LAND TO THE WEST OF HATFIELD

Environmental Statement – Chapter 7: Air Quality Addendum

Arlington Business Parks GP Limited

Following submission of this application, a Peer Review of the Air Quality Chapter to the Hatfield Business Park ES was prepared by Bureau Veritas (BV report reference: AIR6485266, dated March 2019), as part of the wider The Environment Partnership (TEP) review to the Environmental Impact Assessment (EIA) (TEP report reference: 7494.001, dated March 2019). Within the Peer Review, BV highlighted a number of 'recommendations' to increase the robustness of the assessment.

Figure 7.4: Land West of Hatfield AQIA – Applied Diurnal Profile Factors

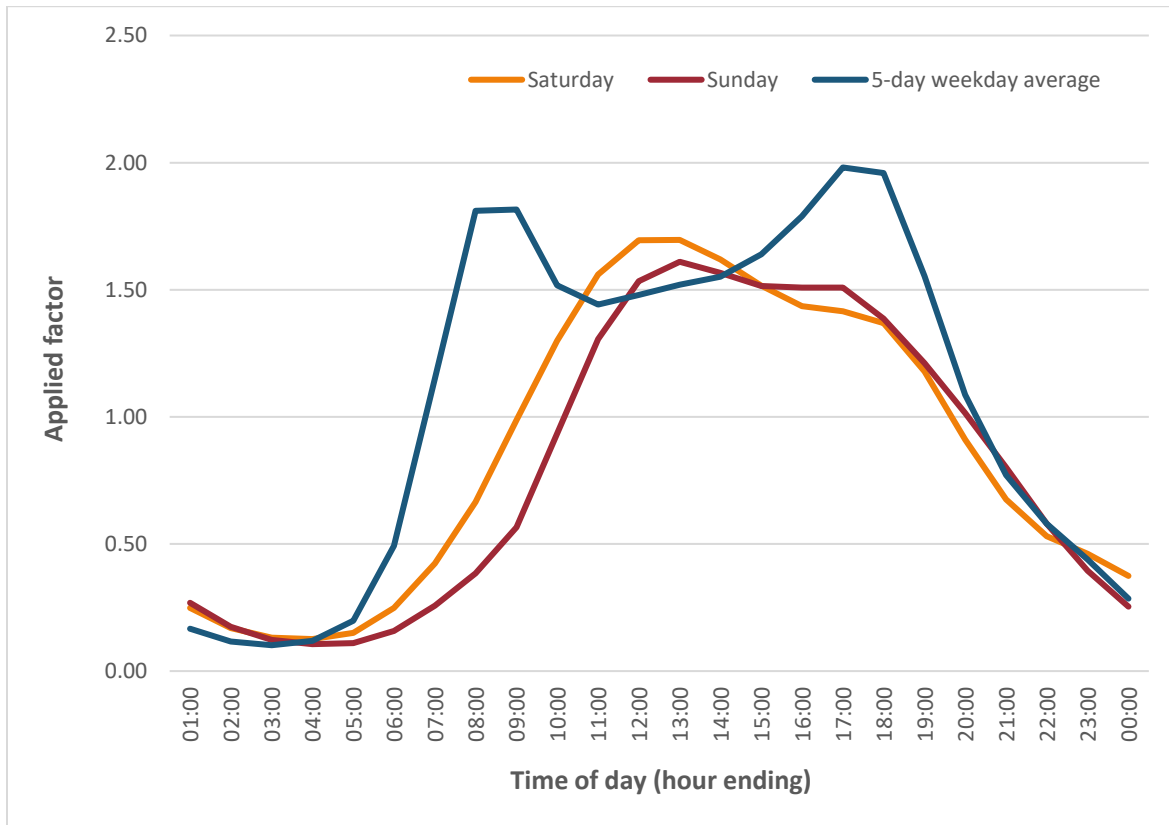
- *Inclusion of a diurnal profile – A diurnal profile within the dispersion model to take account of changing traffic flows throughout weekday and weekend time periods.*

Reference should be made to Table 7.12 and Figure 7.4 for details of the applied diurnal profile factors applied within the ADMS Roads dispersion model.

Figure 7.5: Receptor Position Relative to the R1 roundabout / modelled A1(M) north of the Hatfield Tunnel Road Sources

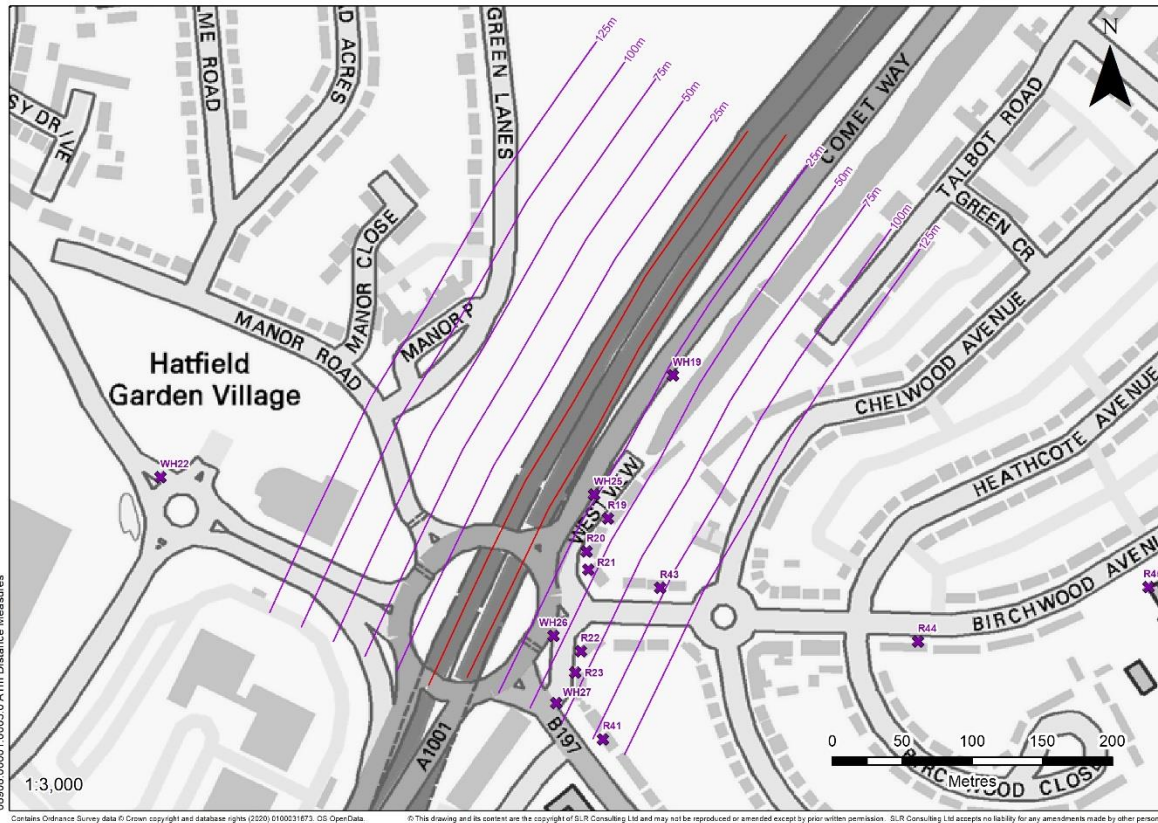
- *The A1(M) road link not included within the modelling assessment*
- *Diffusion tube locations WH24 and WH27 no [sic] used within the verification calculations.*
- *The RMSE for the verification calculations being above 10%.*
- *Diffusion tube WH16 not being report upon [sic] in terms of background concentrations.*
- *The Sector Removal Tool not being utilised.*
- *Clarification on traffic data baseline factors.*
- *Clarification on model inputs, canyons, terrain, etc.*
- *A diurnal profile not included within the modelling assessment.*
- *Limited information on the classification of potential impacts from the quarry extension.*
- *Results of the sensitivity analysis not being discussed.*

- *Review of model verification – Sites WH24 and WH27 should be included within the initial step for model verification and all model inputs should be reviewed to potentially improve the accuracy of the verification leading to a lower verification factor. Once completed it should be ensured that the RMSE is below 10%.*

Therefore, it is considered that the model will be performing very differently in the location of the R1 roundabout (and the WH19, WH25, WH26 and WH27 diffusion tubes positioned on this roundabout), and elsewhere within the extent of the considered modelling domain. On this basis, a ‘zonal’ verification factor has been applied to separately consider a ‘roundabout’ verification factor and ‘non-roundabout’ verification factor. The ‘roundabout’ verification factor has been applied to all receptor locations within 200m of the R1 roundabout / modelled A1(M) north of the Hatfield Tunnel based upon the distance defined within DMRB LA 105⁷, within which road traffic emission contributions from specific roads occur. Beyond this 200m separation distance, emission contributions from the R1 roundabout / modelled A1(M) north of the Hatfield Tunnel would reduce. It is noted that receptor locations have been digitised and modelled based upon their relative proximity to the R1 roundabout / modelled A1(M) north of the Hatfield Tunnel (i.e. within approximately 100m) OR at separation distances in excess of 200m. Reference should be made to Figure 7.5 for an illustration of receptors and their proximity to the R1 roundabout / modelled A1(M) north of the Hatfield Tunnel road sources to illustrate this.
